At the ZBA meeting of 3/21 focusing on traffic impacts of the Sudbury Station application, many specific issues and concerns were raised which I will summarize below. In addition, there were serious process issues raised that call into question whether this application can be vetted effectively.

The following specific traffic and safety issues were raised that need further study and responses:

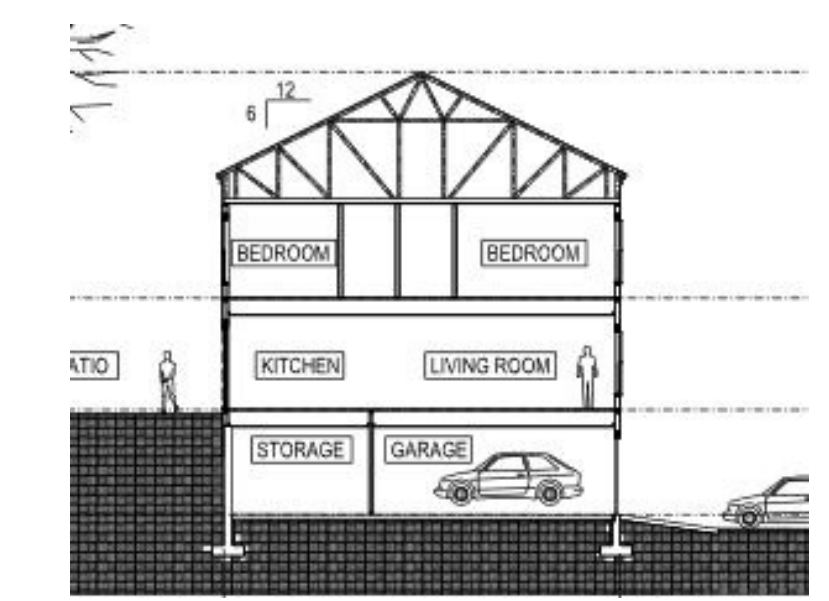
Calculations based on the following assumptions.
 There are 4 building types, with a total of 11 buildings. I did the following:
 - took the square footage footprint of each building type and multiplied by the quantity of buildings of that type

- added the total square footage of all building types
 - multiplied that by 6. On the site plan most buildings are on a slope that is 12' from the high side edge to the low side. If we assume that the low side is a grade level (and not elevated), then we have a triangle where the low side is at zero and the high side at 12'. The average depth (midway point) of that triangle is 6'. Based on this assumption, an average of 6' depth of earth times the building footprint would have to be removed for each building to create a level platform for parking.

- I divided the total by 27, which converts cubic feet to cubic yards
 - I divided that total by 14, which is the number of yards of earth that fit into an 18 wheel dump truck

- I multiplied that by 2, because each truck that hauls dirt out has to return empty, and we are counting total trips to and from the site.

contour lines graphed at 2' vertical offset

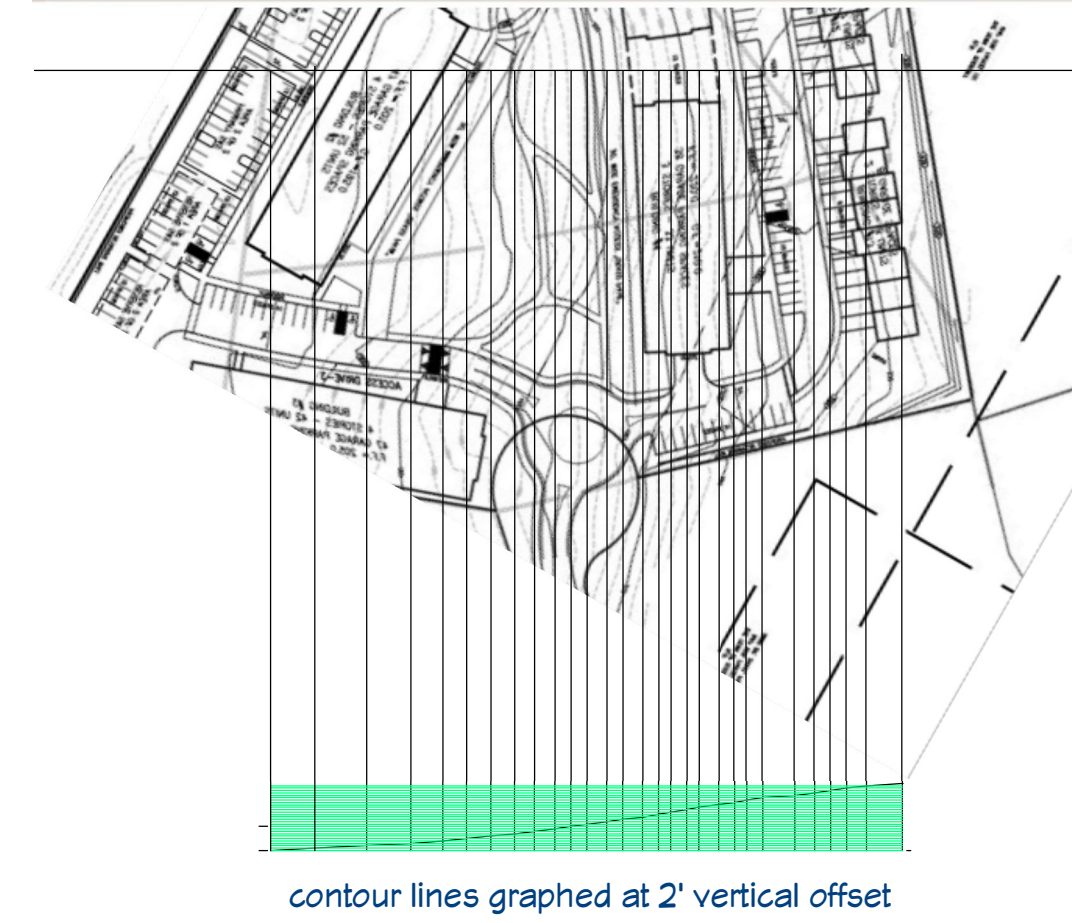
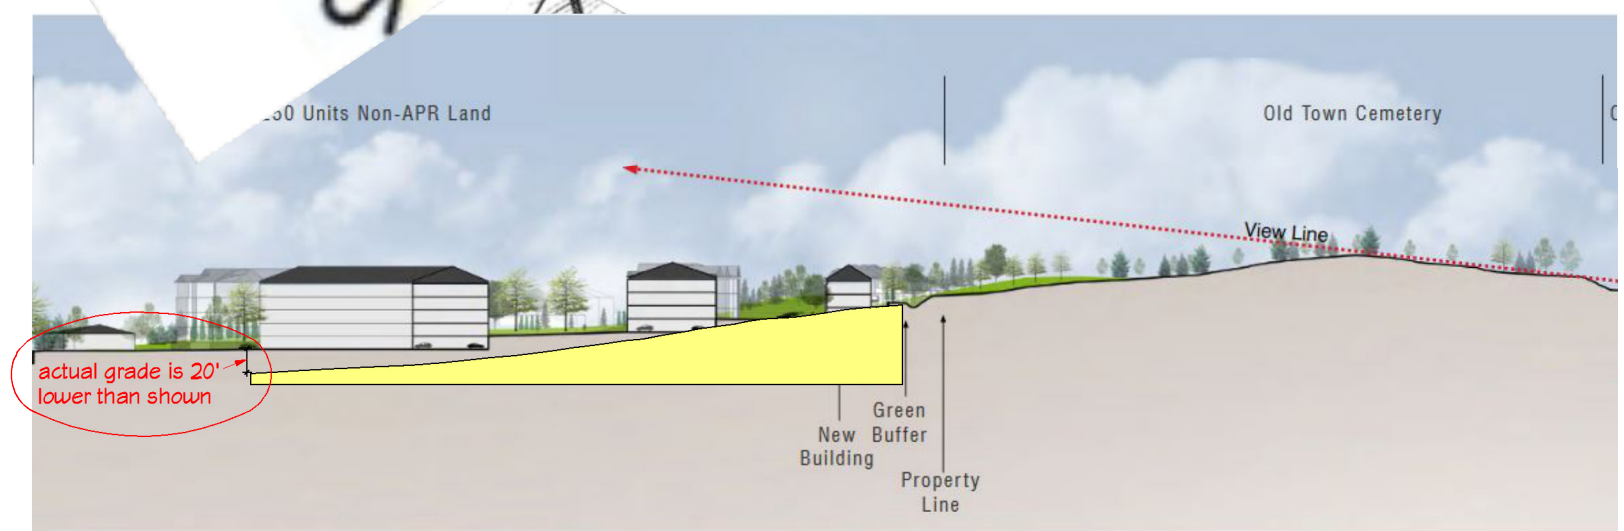
Methodology:
 These images are taken from the developer's application. The top image is a plan showing where section 1 is taken. The middle image is section 1 showing buildings on a slope. The lower image is a plan showing the topo lines (contours) which are at 2' vertical intervals.
 On the plan, the contours have been graphed with vertical lines from each contour, going to the green box, which shows the true slope of the site. That slope has been placed as a yellow wedge in the section drawing, to contrast it with the slope shown in the section. I contend that the developer's section shows a site that is significantly flatter than what exists. Retaining walls are not shown to indicate that the site will be filled.

Also note that this calculation did not include excavation and earth removal for road beds. If the typical road is at least 15-20' wide, it would span about 6-8' in slope, of which half would need to be removed to create a level road bed (it could be cut and fill, but then the filled side would have to be retained). Assuming a minimum of 2500 linear feet of road, times 15' wide, creates 37500 sq' road, x3' depth avg excavation, equals 112,500 cubic ', or 4166 cubic yards, divided by 14 (dump truck) equals another 297 truck loads, times 2 (return trip) equals 595 truck loads.

Figure 1: 3D computer model showing accurate slope based on GIS data and approximate location of buildings

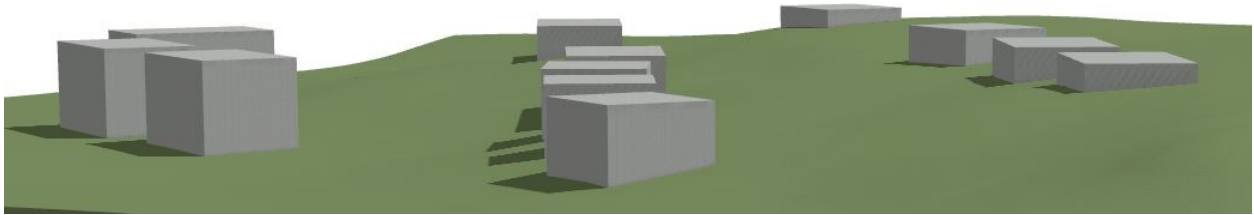
Since the developer has not provided any grading or section information, I have made rough calculations based on the plans and sections submitted. According to GIS maps, the top of the building area where the clubhouse is located is approx. elev. 250'. Drawing a line parallel to Hudson Rd. towards the RR track is a distance of approx. 700' and descends to approx. 185' at the trackbed, for a difference of 65' creating a slope of approx. 6 degrees. As the access road progresses uphill from Hudson road, the slope becomes steeper. The drawings indicate that most parking will be below grade, at least on the uphill side. Given an average building footprint of 13,000', and an average excavation per building of 5' (half underground), a total of 65,000 cubic feet per building, or 715,000 feet for 11 buildings, will have to be removed. This does not include additional excavation for footings and foundation walls. There is approx. 4500 linear feet of roadway at 20' wide (including sidewalks or shoulders), equaling 90,000 square feet x at least 3' deep to compensate for the slope and provide a level roadway, equaling 270,000 cubic ft. If we add the building and roadway area we have 985,000 cubic feet, or 36,481 cubic yards of material to be removed.

Note, I have not figured any removal of material for regrading of the site other than the area directly under buildings and roadways. Typically, projects on slopes are constructed with the cut and fill method, where material is removed from the high side and added to the low side. However, this assumes that either a) there is enough room to create a gradual slope on either side of the "plateau" (not possible on this narrow lot), or b) there are retaining structures on both the high and low sides (which are not indicated on the plans). Therefore, we must assume that this material is be removed from the site. (note, this does not include the considerable earth removal related to the stormwater detention basin). The largest overroad dump truck carries 14 yards of earth. If we divide 36,481/14, we have 2,605 truckloads of material removed from the site. Since each truck must make a return trip empty, we are facing a minimum of 5,211 dump truck trips during construction. This does not include the many trips incoming to the site to deliver gravel, concrete, and building materials. Some of these trucks will not be able to make the turn into the site as currently shown. When the Big Dig was underway, the "haul road" was built specifically to keep large trucks off of normally travelled roads to avoid creating traffic jams, accidents, and destroying the roadway and infrastructure. Clearly, this is not an option here.

The health and safety issues under review by the ZBA include issues related to construction. I strongly urge the board to request information from the developer regarding the earth removal issues raised herein, at this time, before any more peer review of incomplete traffic and safety data is undertaken. Since large trucks pose far more safety issues than cars, we must have a detailed understanding of the safety impact of thousands of trucks on our congested and narrow roads. Answers that do not include accurate topo sections based on stamped engineering drawings should be rejected. If the developer is unable to provide the necessary information at the proper level of detail, the process should be halted until such information can be provided.
